**Turkey Creek Regional Sewer District
Fascination Place
Water Main Improvements**

ADDENDUM 2

January 30, 2026

Plan holders on the Turkey Creek Regional Sewer District, Fascination Place Water Main Improvement, are hereby notified of the following amendments to the contract documents. This Addendum is hereby made a part of the Contract Documents.

SHEET NO. W-0.2

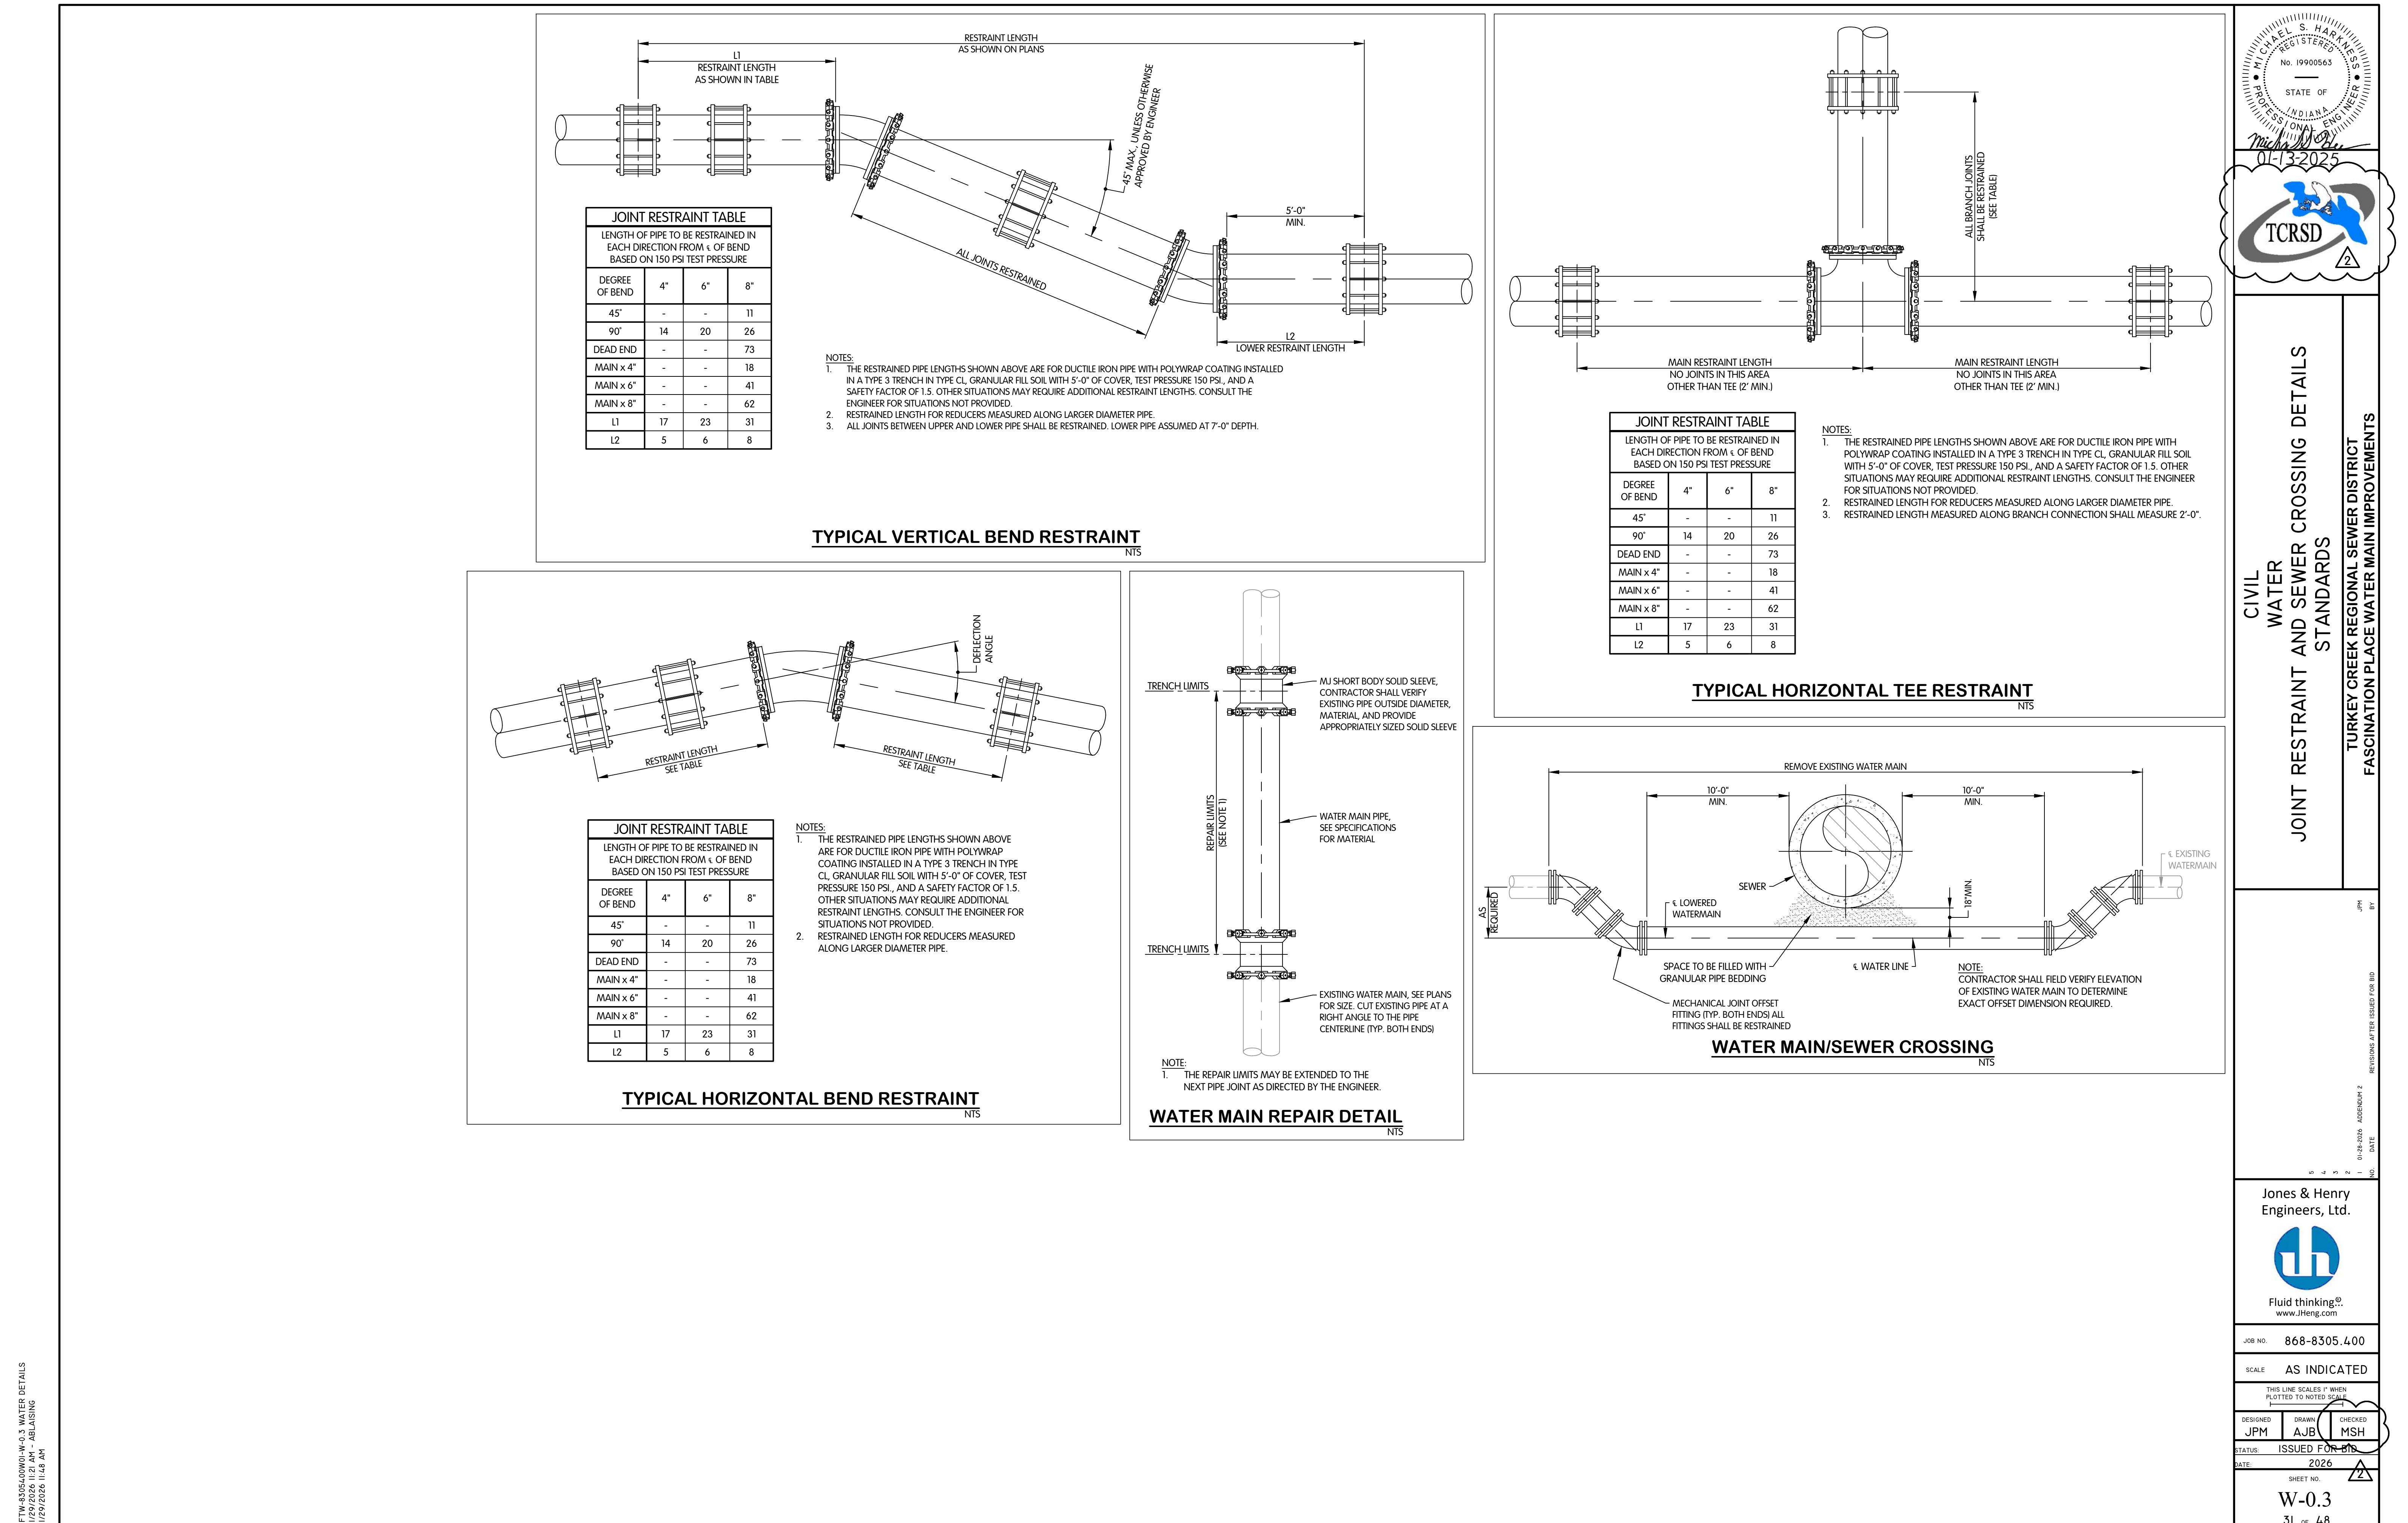
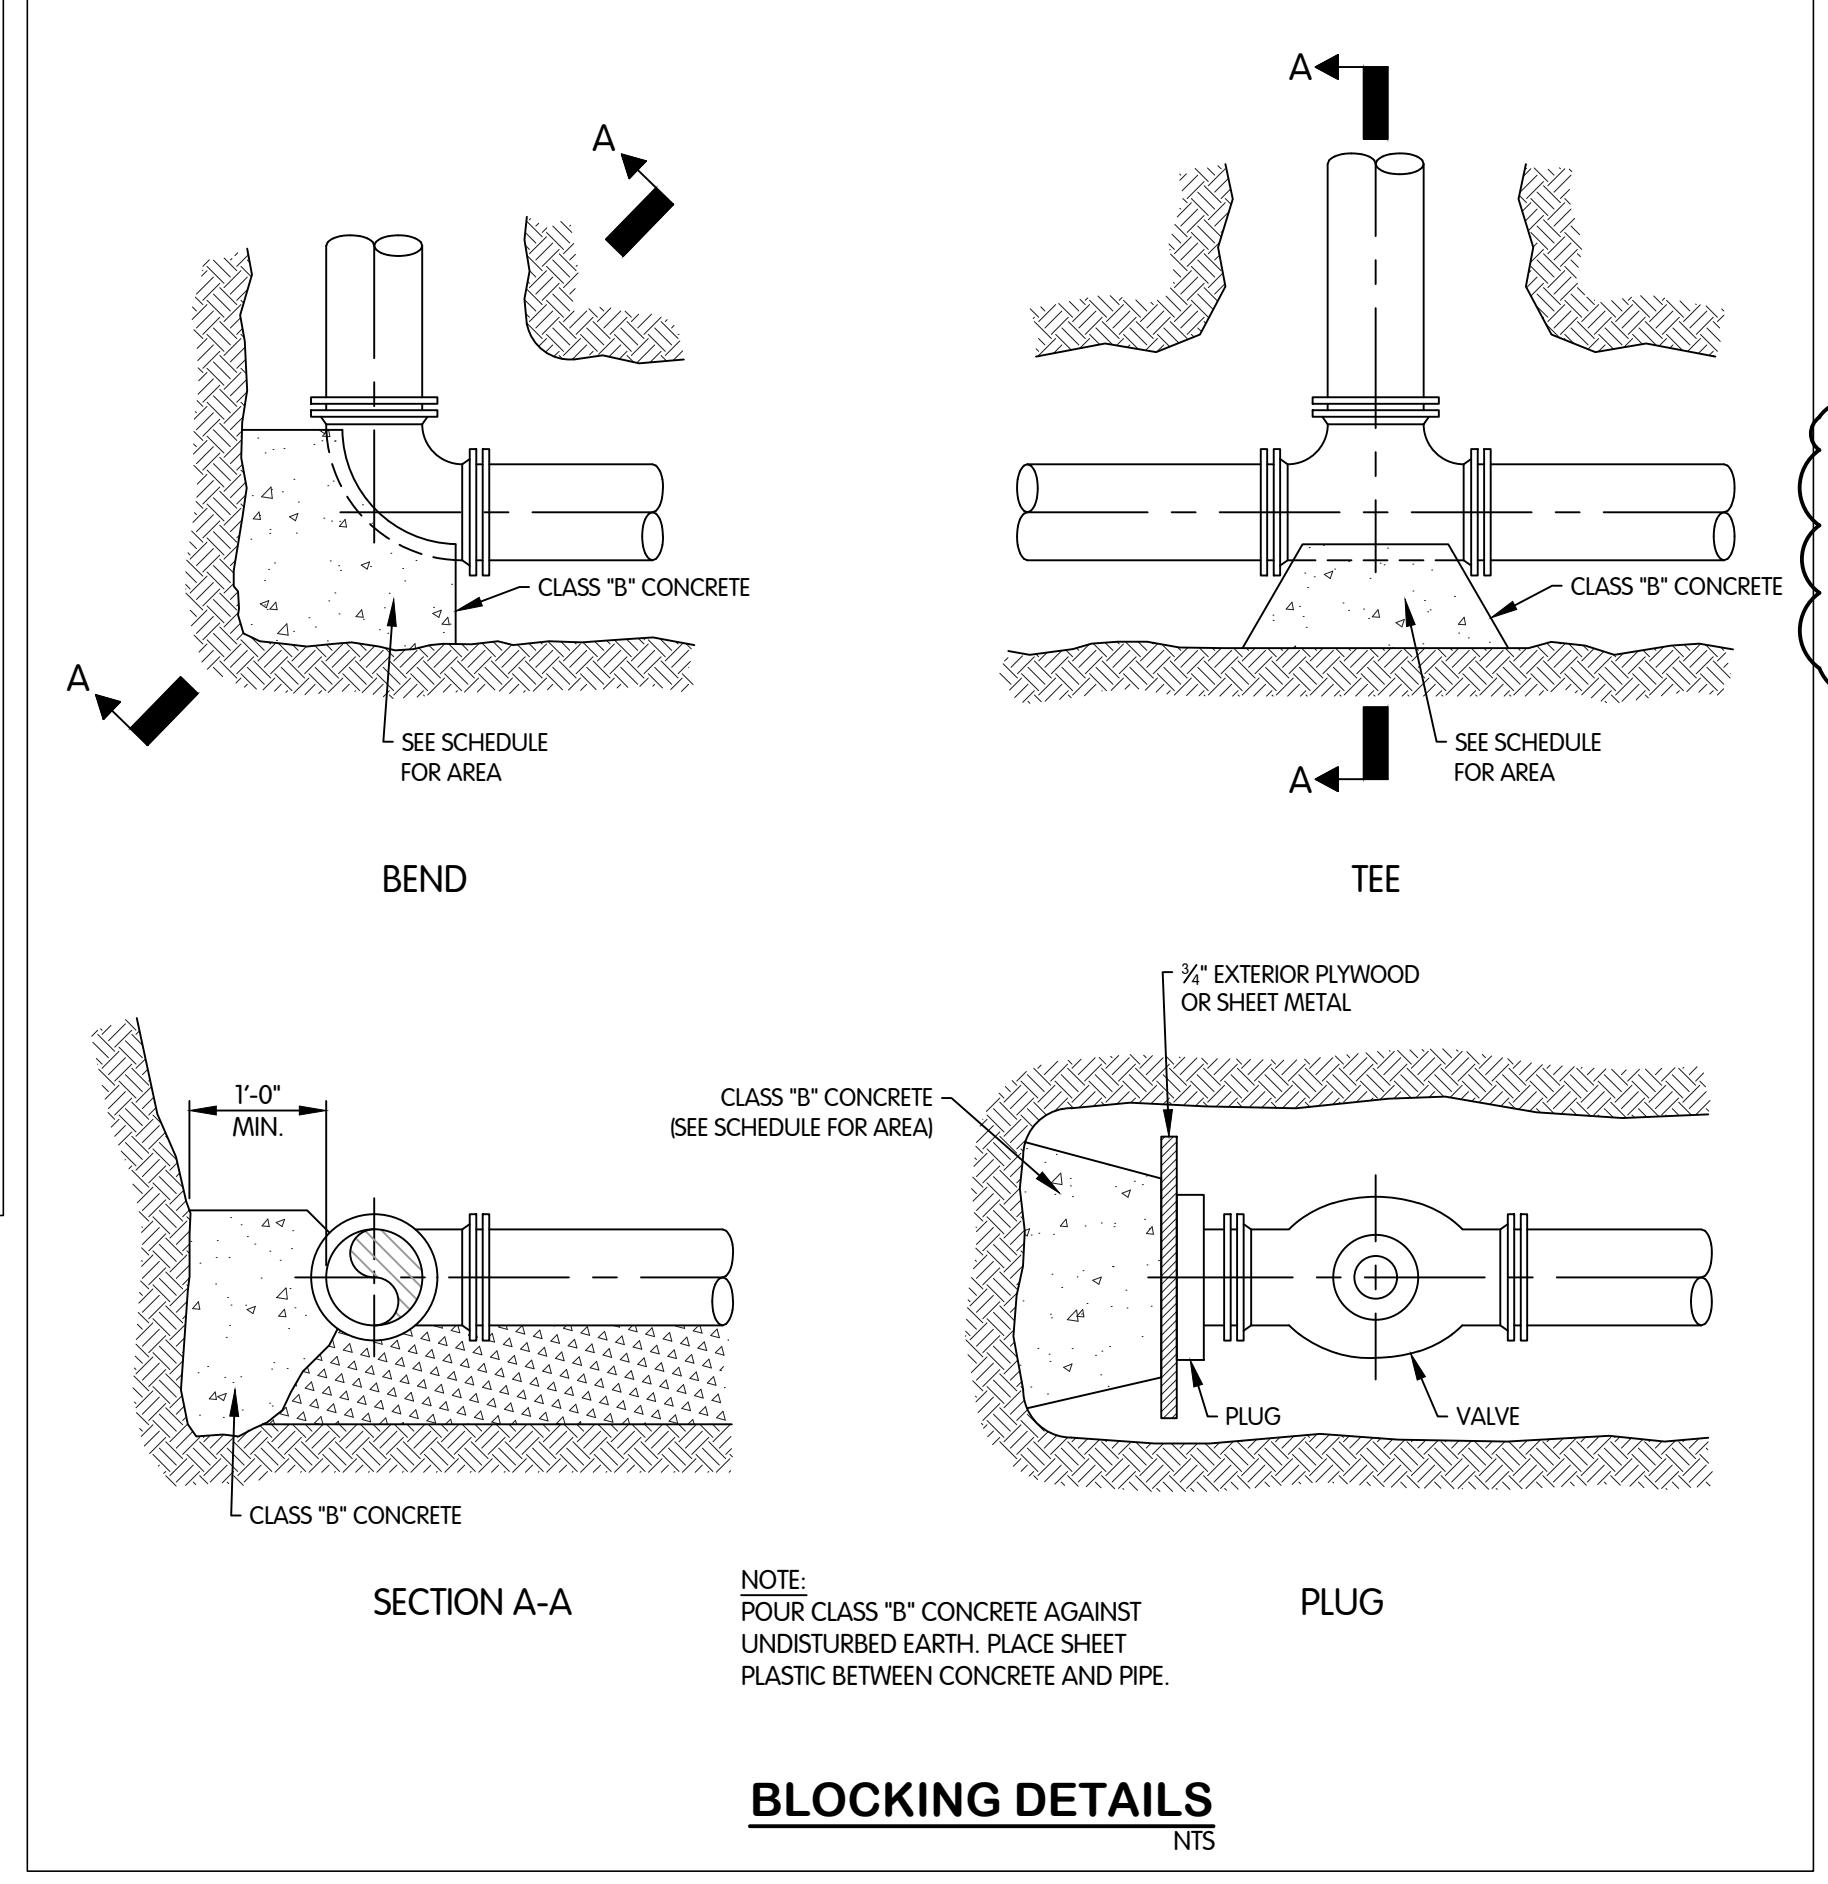
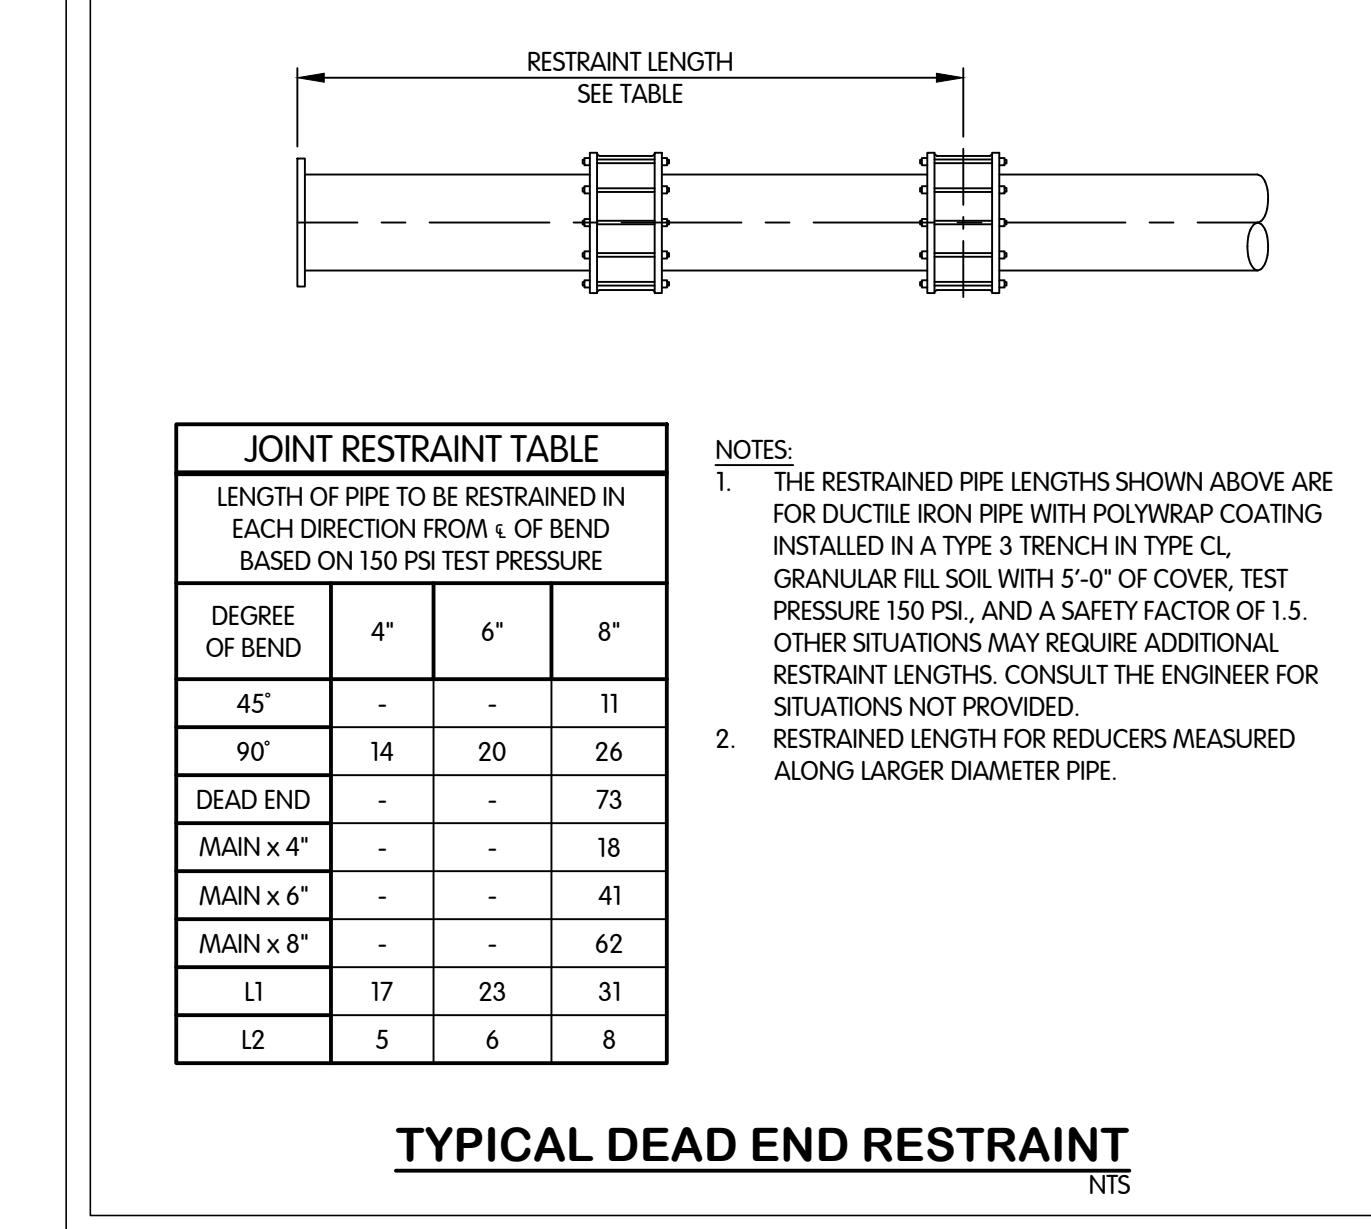
All Sheets: Delete and replace all sheets, missing logo and checked by note, added sheets G-0.5- (General Summary), & SR-0.4- (Erosion Control Narrative). Note updates sheet W-0.2.

- a. The service line can be PEXa pipe or copper per the Specification section 02558. Drawing sheet W-0.2 only states copper but PEXa is allowed. We will add this note to the drawing.
- b. The project will require erosion control. Turkey Creek RSD will apply for the SWPPP. The contractor will have to provide erosion control per the plan.
- c. Meter software setup will be through the contract. The meter supplier will need to provide meter reading services per the specifications.
- d. The contractor shall pay for the Electronic Project Management System (EMPS). It will be part of Modulization costs.
